Service Campaign Notification

Campaign #	Description	Retrofit Heat Shield on Integral Carrier
2025070007	25P4990104

CAMPAIGN NO.	2025070007
CAMPAIGN DESC.	25P4990104
SUBJECT	Retrofit Heat Shield on Integral Carrier
MODEL(S)	CLA, GLA and GLB (118 and 247 platform)
MODEL YEAR(S)	2024
CAMPAIGN POPULATION	5,810

Figure 1 – DoT = Direction of travel (installation position)

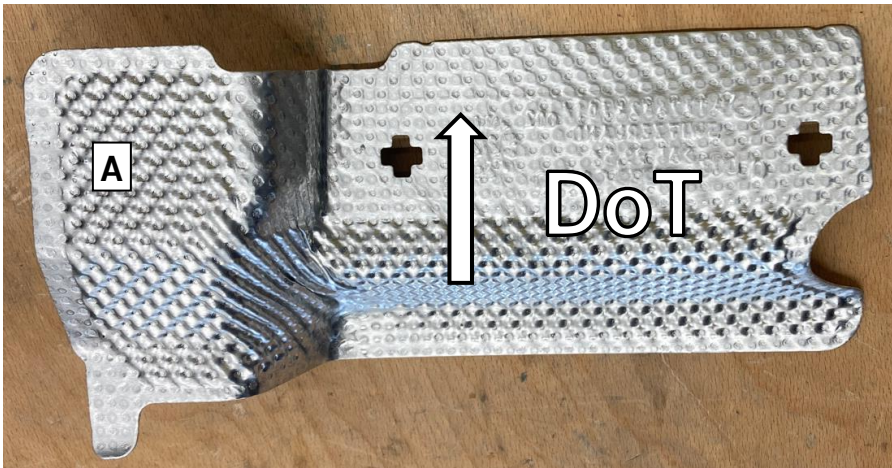
Retrofitting heat shield (Figure 1, A) onto the exhaust system integral carrier.

Figure 2

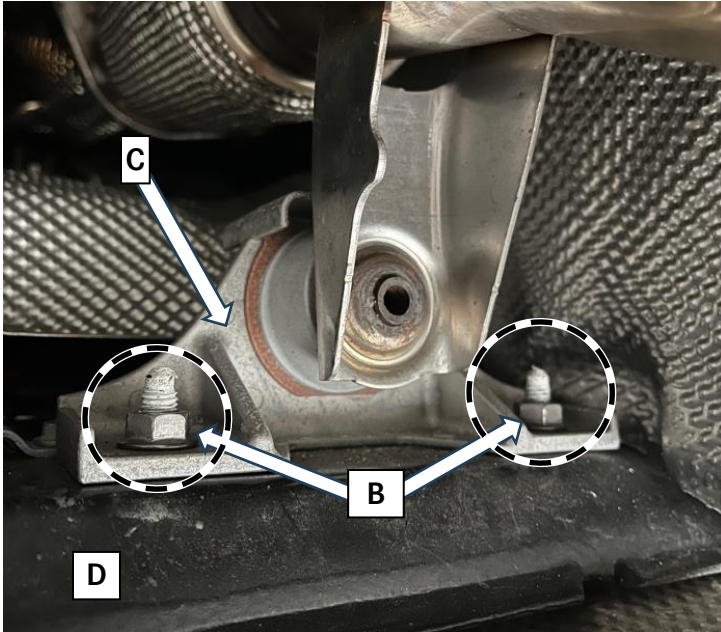
1. Lift vehicle with vehicle lift (AR00.60-P-1006A).
2. Unscrew nuts (Figure 2, B) from the exhaust system holder (Figure 2, C) on the integral carrier (Figure 2, D).

Hm Installation (Figure 2, B): Tightening torque 24 Nm!

Figure 3

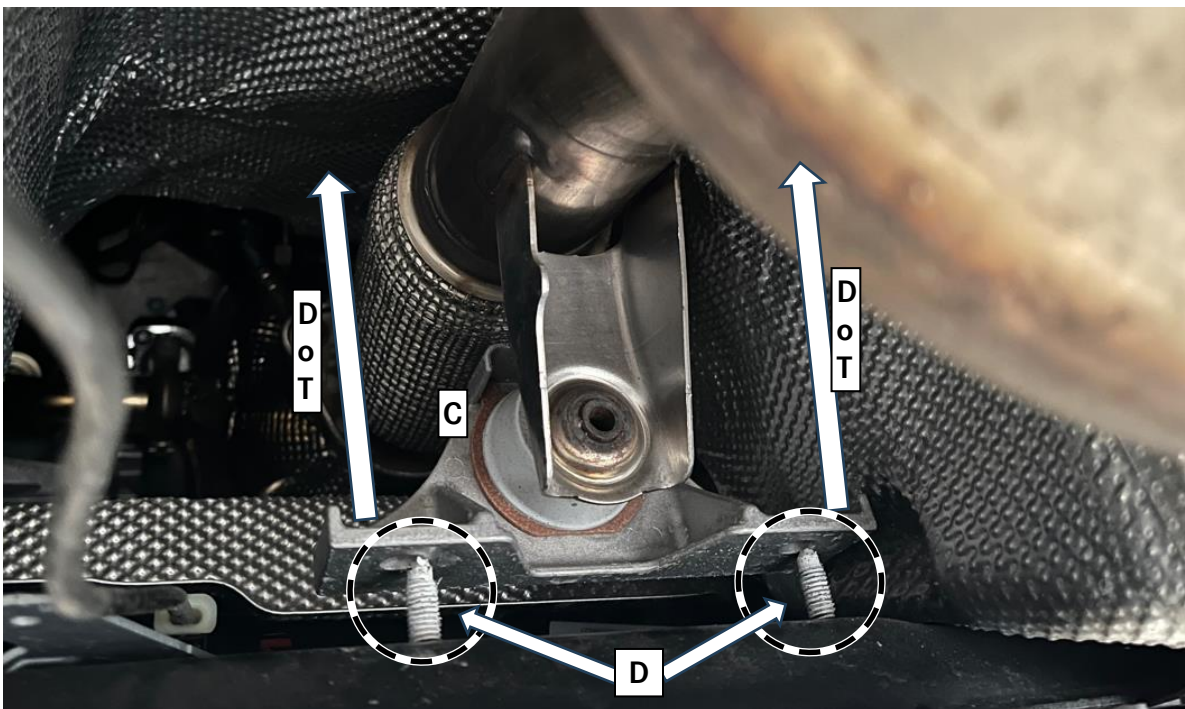
3. Gently lift the exhaust system with holder (Figure 3, C) in the direction of travel.

i Only lift far enough (Figure 3, DoT) so the heat shield (Figure 1, A) can slide over the integral carrier studs (Figure 3, D). Otherwise, there is a risk of damaging the exhaust system!

Figure 4

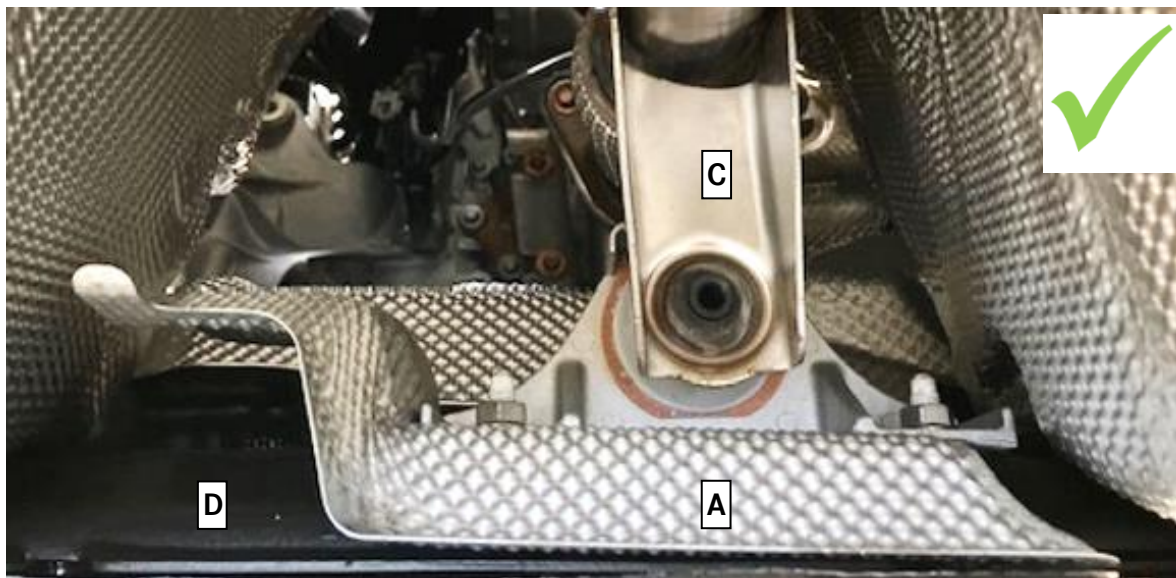
4. Position heat shield (Figure 4, A) in the correct installation position on the integral carrier studs and lower the exhaust system holder (Figure 4, C) back onto the heat shield.

i Heat shield (Figure 4, A) is correctly mounted if it is **between** the exhaust system holder (Figure 4, C) and the integral carrier (D, figure 4).
